Subject: North Anna Unit 1 Cooldown
Incident of September 25, 1979

RESPONSE TO REQUEST FOR ADDITIONAL
INFORMATION RELATED TO THE
SEPTEMBER 25, 1979 EVENT

Figure 15.2-43 Transient Response for a Steam Line Break Equivalent to 262 lbs/sec at 1020 PSIA With Outlets Power Available

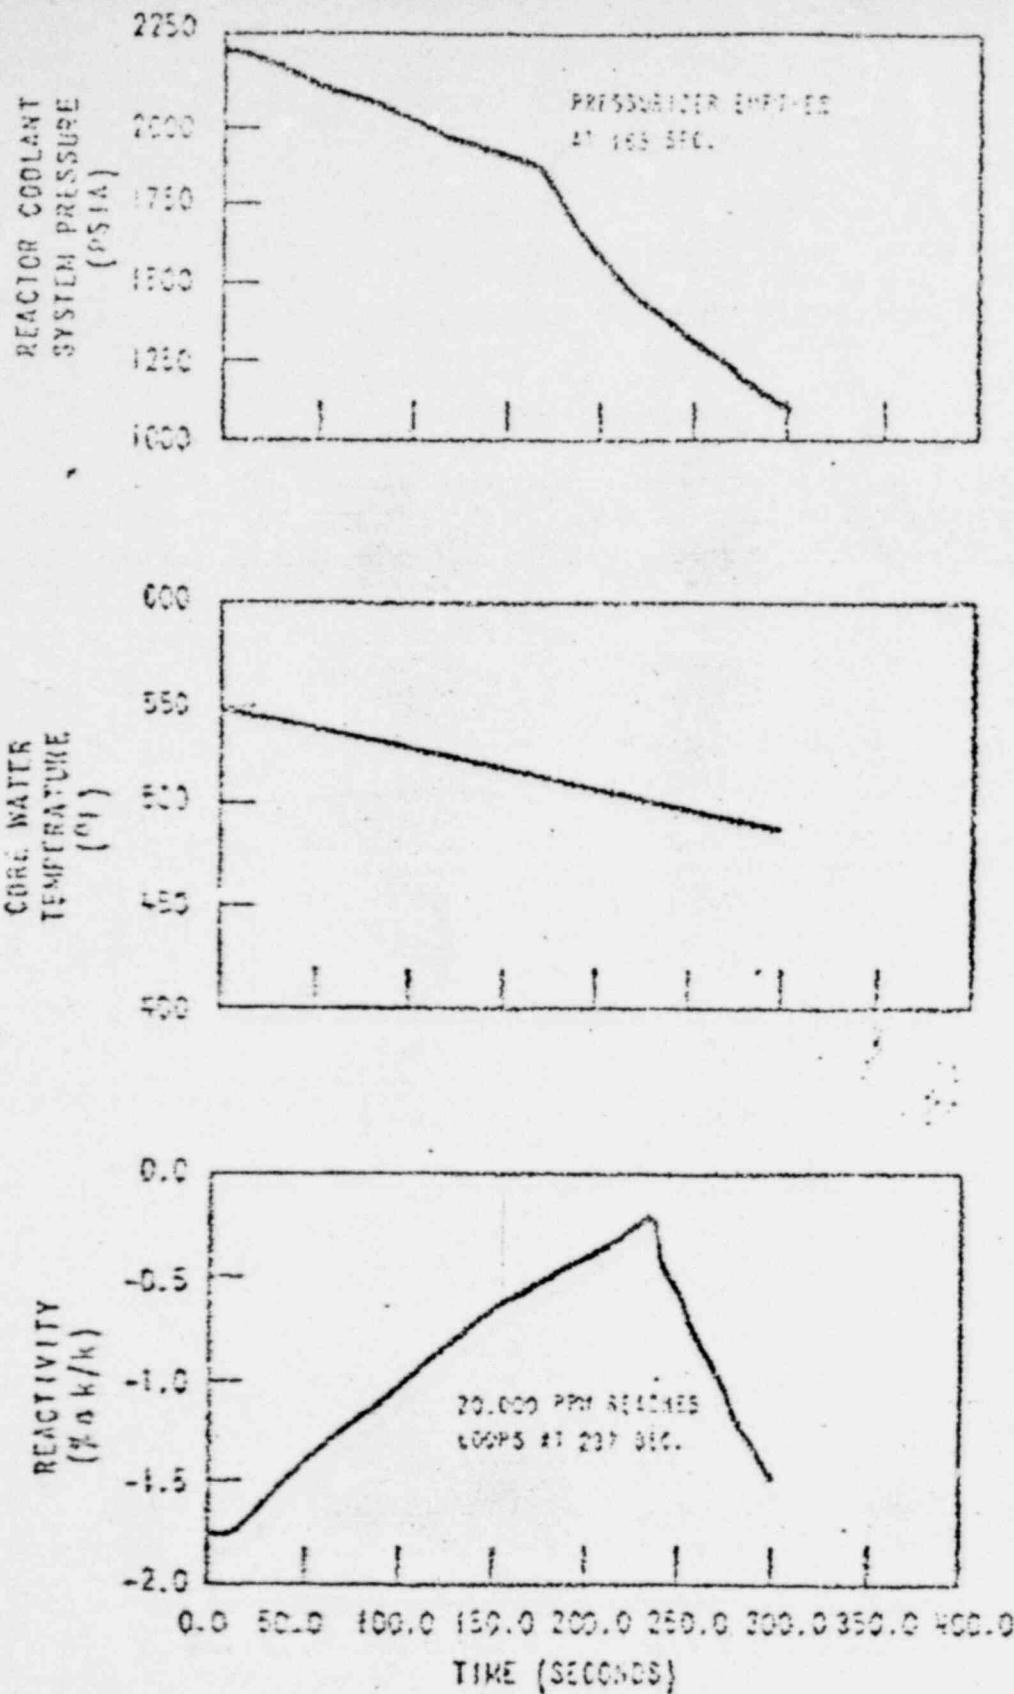
Question 1. Perform an engineering analysis of the Sept. 25, 1979 event, identifying all of the significant initial conditions, and provide a comparison with events analyzed in Chapter 15 of the North Anna FSAR especially with regard to assumed initial conditions, boundary conditions and system failures.

Figure 1 shows the transient response reviewed in the North Anna FSAR and also shows that the plant did not return critical. Therefore DNB did not occur. Figures 2 and 3 show the transient response utilizing the same computer codes and methodology as discussed in the FSAR and Reload Topical (WCAP-9272), however, the assumptions and sequence of events model the Sept. 25, 1979 event at North Anna 1. The transient results show that the pressure reduction, temperature cooldown and margin to criticality are all less limiting than the case analyzed in the FSAR. Thus the FSAR analysis remains bounding.
